UNIVERSITY OF MISSOURI-COLUMBIA

Research Reactor Facility

REFERENCE: Docket 50-186
University of Missouri Research Reactor
License R-103

SUBJECT: Response to Request for Additional Information dated April 20, 1994

Pool and Weir

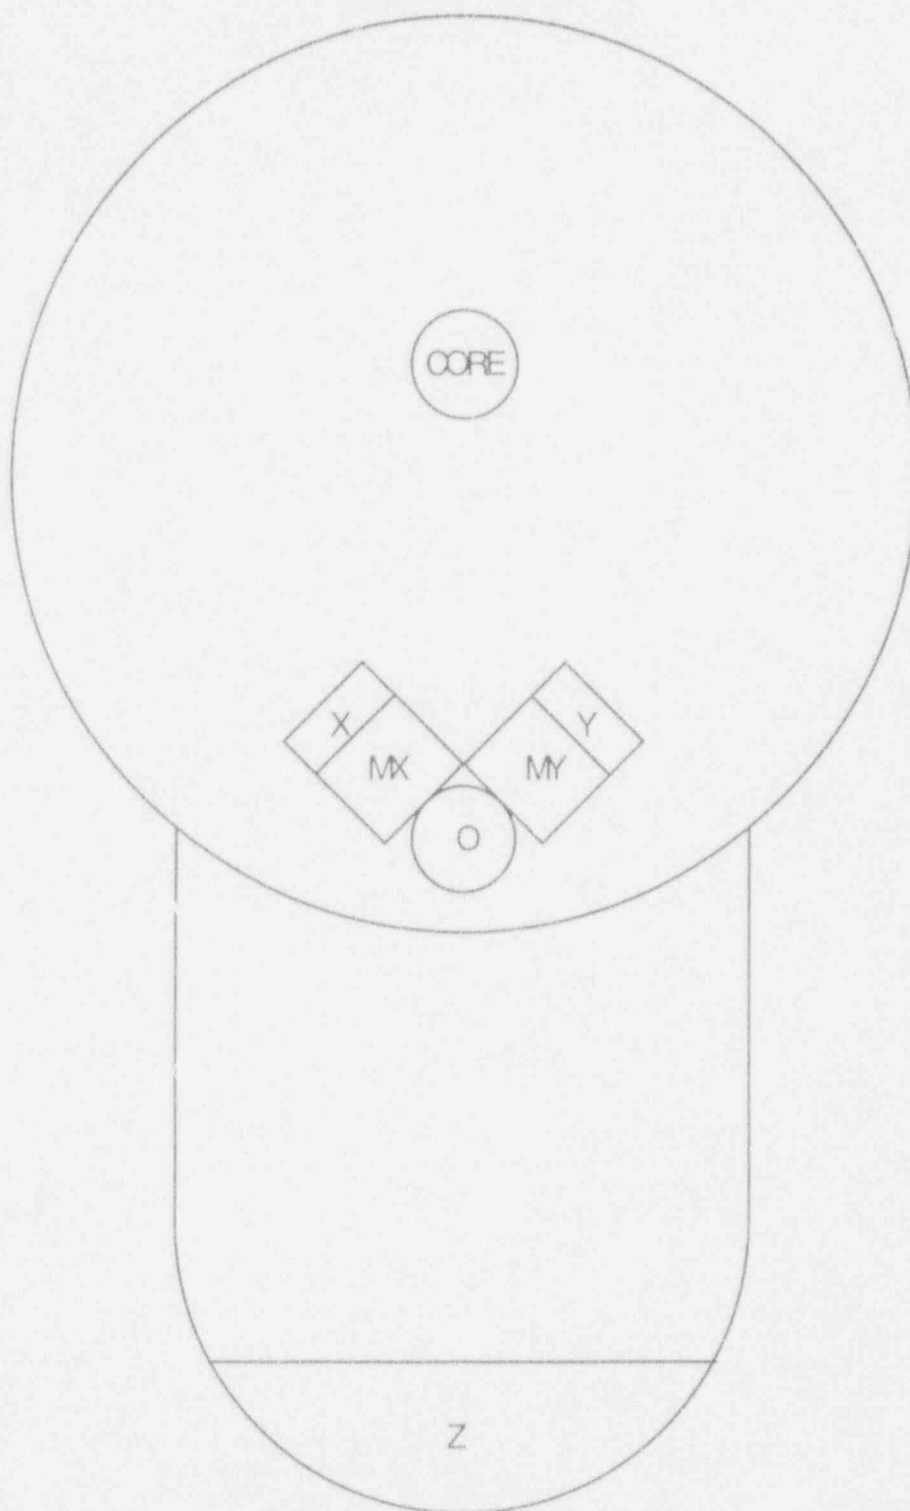
4. *Your amendment request states that the criticality aspects of fuel storage at MURR are not changed by the request. Please provide a discussion of storage racks, k -effective, and stored fuel cooling for the maximum amount of fuel that will be in storage during the period of the proposed increased possession extension.*

The attached diagram shows the fuel storage baskets in the MURR pool. Using the KENO code, we calculated $k_{\text{eff}} = 0.75$ for the baskets X, Y, MX, MY, O, fully loaded with new 775 gram U-235 elements. This is conservative, since elements stored in these baskets always have some burnup and are less than 775 g U-235. Similar calculations have shown that k_{eff} for the fully loaded Z baskets is less than 0.8. These in-pool storage locations are capable of storing 92 fuel elements.
